## The Essentials of Computer Organization and Architecture 2<sup>nd</sup> Edition

Linda Null and Julia Lobur  
Jones and Bartlett Publishers, 2006

# Errata (1<sup>st</sup> Printing)

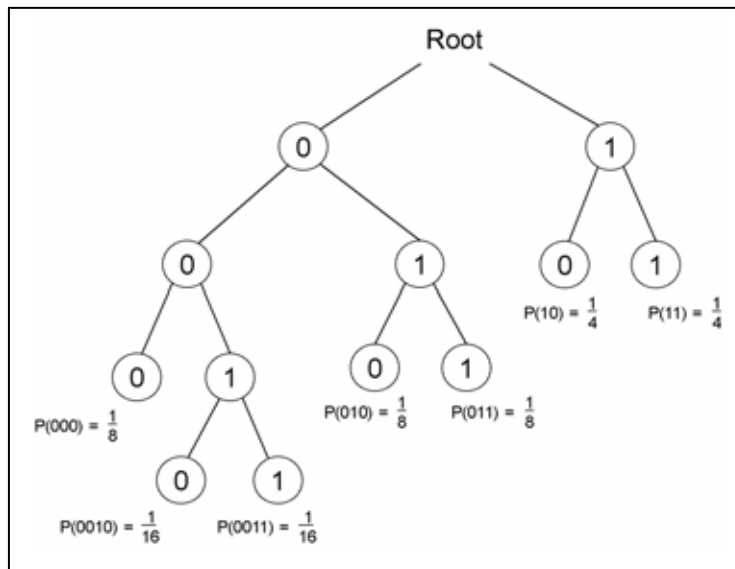
105 F2A.6: The node numbers are difficult to read because the lines were pushed into the nodes. The correct figure is as follows:

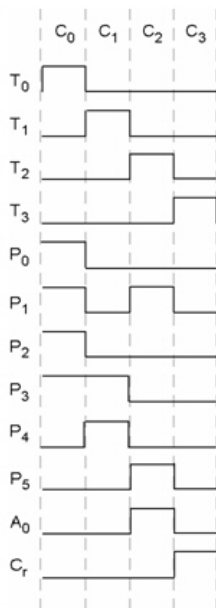
217 F4.16: In clock cycle  $C_1$ , signals  $P_3$ ,  $P_4$ , and  $T_1$  should be high, nothing else, so replace Figure 4.16 with the following:
